Pre-Design Investigation
(Additions)

ADDRESS _____ ZONE ATLAS # H-20

CITY OF ALBUQUERQUE
PUBLIC WORKS DEPARTMENT

CAN H 4516-75 BLVD. N.E.

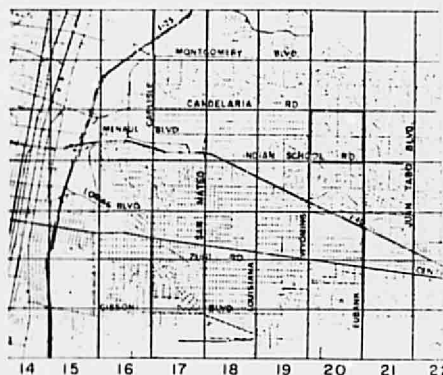
1. Finish Floor elevation, water from new building to be routed towards Eubank, show location of roof spouts and also show flow pattern of existing flows

11/3/82 Need T.B.M. to M.S.L. on site to build the foundation to the required elev. set by Mike Gribb.

Approval to be granted only for the Butler Building going in roof drains to be drained toward Eubank talked to Mike on 11-11-82
